Docket No. 50-346

November 25, 1978

In accordance with our commitment made during the October 25, 1978 meeting with the NRC staff on the Davis-Besse Nuclear Power Station Unit 1 Fire Protection Program, enclosed is Revision 4 to our Fire Hazard Analysis Report. Revision 4 provides responses to items 8, 9, 11, 13, 26, 35, 37 and supplemental question no. 2.

DIRECTIONS FOR INSERTING REVISION 4 OF THE FIRE HAZARD ANALYSIS REPORT

SK-18  
WET PIPE SPRINKLER SYSTEM SPRINKLER  
ARRANGEMENT FOR SERVICE WATER PUMP ROOM

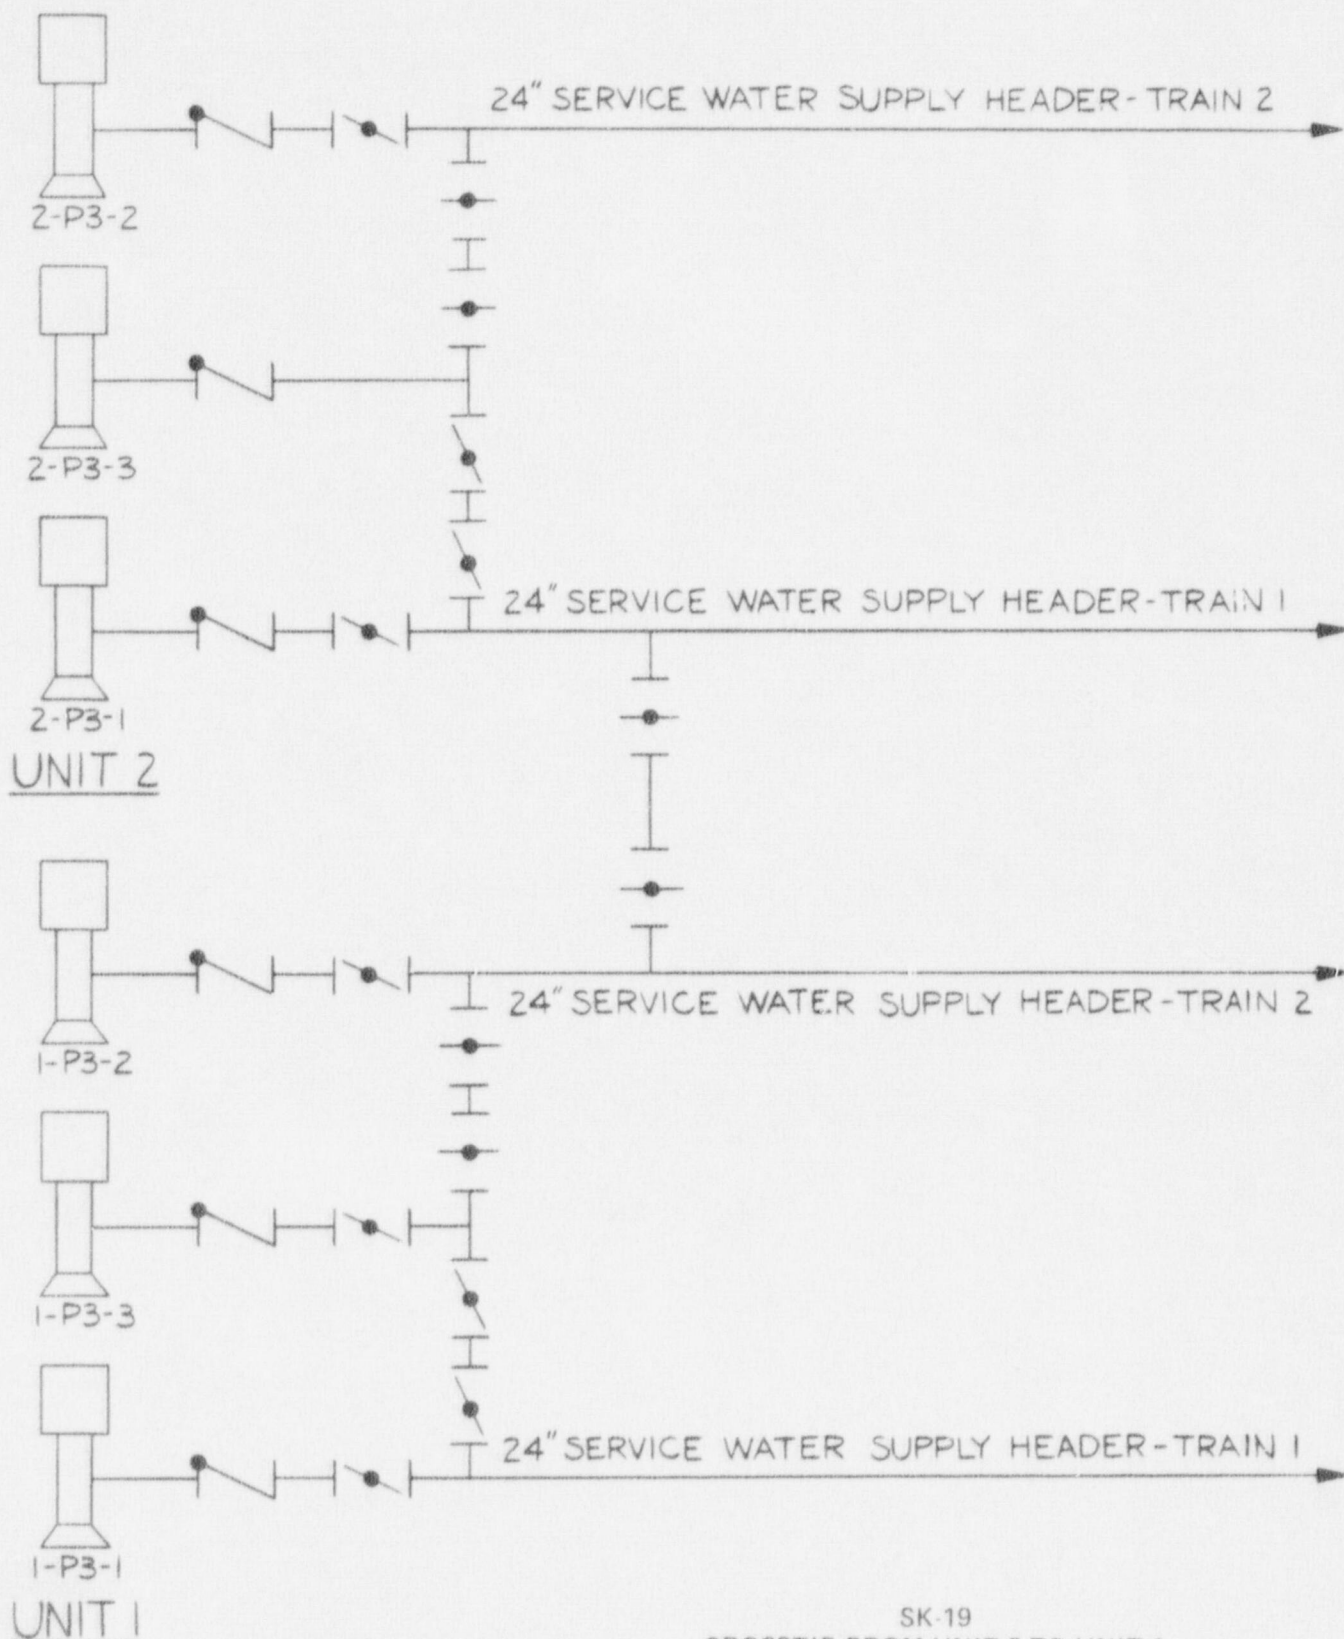
All three service water pumps and two cooling tower makeup pumps are located in one room of the intake structure. It is our position that a noncombustible 1/2-hour rated barrier separate each service water pump and motor from its redundant train (two barriers required). The barriers should be extended from floor to ceiling. Also provide a preaction sprinkler system to cover the entire room, except the motor control center with alarm and annunciation in the control room. Any redundant cabling or conduit from one train within the barrier of the other should be totally enclosed in Kaowool or other suitable material to give at least a half hour fire rating.

All openings in the wall separating this room from the diesel fire pump room should be sealed with a material to achieve a 3-hour fire rating. Also provide a curb around the entrance to the SW pump area on the fire pump side to prohibit a liquid from running under the door separating the two rooms.

It is also our position that you provide a 1-1/2 inch hose station in the immediate area of the service water pump room within the intake structure to cover all portions of any area containing safety related equipment.

The sprinkler system will be designed to spray each pump and motor. Each of the service water pump motors will be baffled to protect it from impingement of water other than in the vertical direction. The motor is protected from water impinging vertically due to its drip proof design. The system will also cover the room floor area for protection from an exposure fire. (Water-sensitive components such as MCC's will be protected.) The sprinkler heads, with installed heat collectors in accordance with NFPA 13, will be distributed immediately below the conduit and above the pump motors and adjacent open areas approximately 7 to 8 feet from the floor. The spacing between heads will be no more than 10 feet nor less than 6 feet on centers. A preliminary arrangement is provided in Appendix 1 as Drawing SK-18.

The sprinklers will use fast-response heads with a temperature setting of 135F. These are Grinnell Model F931-type sprinklers which consist of a Duraspeed-type head and a quick-response actuator. They are designed for rapid thermal detection of a fire and do not impair normal operation or water discharge characteristics of the sprinkler. When tested by Underwriters Laboratories (listed under the "Sprinklers, Quick-Response Sprinkler Assemblies (VORQ)" classification), the average mean time of actuation, when subjected to the Laboratory's sprinkler air-oven operation test, was 33.9 seconds at an average operating temperature of 186.7F.

The floor around each service water pump will be sloped or curbed sufficiently so that oil leaking from any one pump or motor or a flammable liquid spill at the pump motor will be confined to the immediate pump area.

In order to provide manual fire-fighting back up, a 1-1/2-inch hose station will be provided in the area of the service water pump room within the intake structure.
